Access Compliance Report

Public Rights-of-Way

Intersection ID: 29462	Main Street: E_10TH_ST	Cross Street: GARDEN_DISTRICT_DR	Location: S
ADA ID: 3D107E81063D	Ramp Type: Perp	Initial Pass/Fail: Fail	Overall Compliance: No
		Severity Score: 25

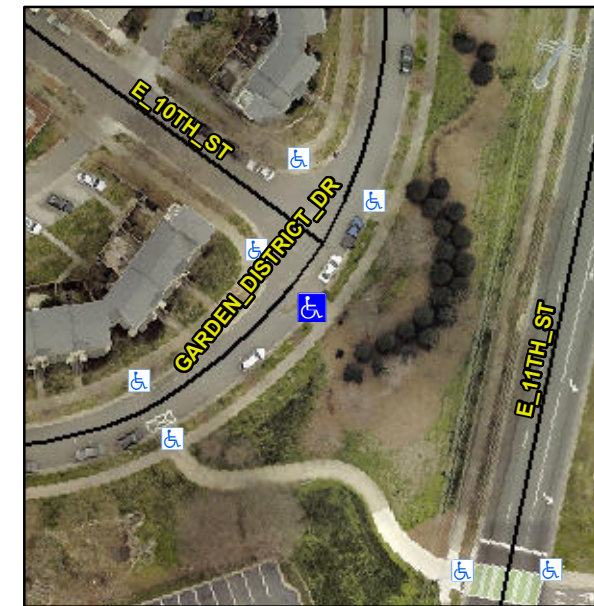
R304.2.2

Compliance	Description	Data	Compliance	Description	Data
N/A	Ramp Length (in)	62.0	No	Ramp Slope (%)	14.4
Yes	Ramp Width (in)	120.0	Yes	Ramp XSlope (%)	0.7
N/A	Flare Type LT	N/A	N/A	Flare Type RT	N/A
N/A	Flare Slope LT (%)	N/A	N/A	Flare Slope RT (%)	N/A
N/A	Flare Traversable LT?	N/A	N/A	Flare Traversable RT?	N/A
N/A	Landing Length (in)	N/A	N/A	DWS Provided?	N/A
N/A	Landing Width (in)	N/A	N/A	DWS Contrast?	N/A
N/A	Landing Slope (%)	N/A	N/A	DWS Length (in)	N/A
N/A	Landing X Slope (%)	N/A	N/A	DWS Full Width?	N/A
N/A	Landing Curb? (Y/N)	N/A	N/A	DWS Offset (in)	N/A
N/A	Shared Landing?	N/A			
N/A	Gutter Ponding?	N/A	N/A	Gutter Slope (%)	N/A
N/A	Gutter Lip Ht (in)	N/A	N/A	Gutter X Slope (%)	N/A
N/A	Painted X Walk1?	No	N/A	Painted X Walk2?	N/A
	X Walk 1 Direction	To NW		X Walk 2 Direction	N/A
N/A	X Walk 1 Width (in)	N/A	N/A	X Walk 2 Width (in)	N/A
	X Walk 1 Slope (%)	0.7		X Walk 2 Slope (%)	N/A
	X Walk 1 X Slope (%)	0.8		X Walk 2 X Slope (%)	N/A

Remove & Replace Entire Ramp.
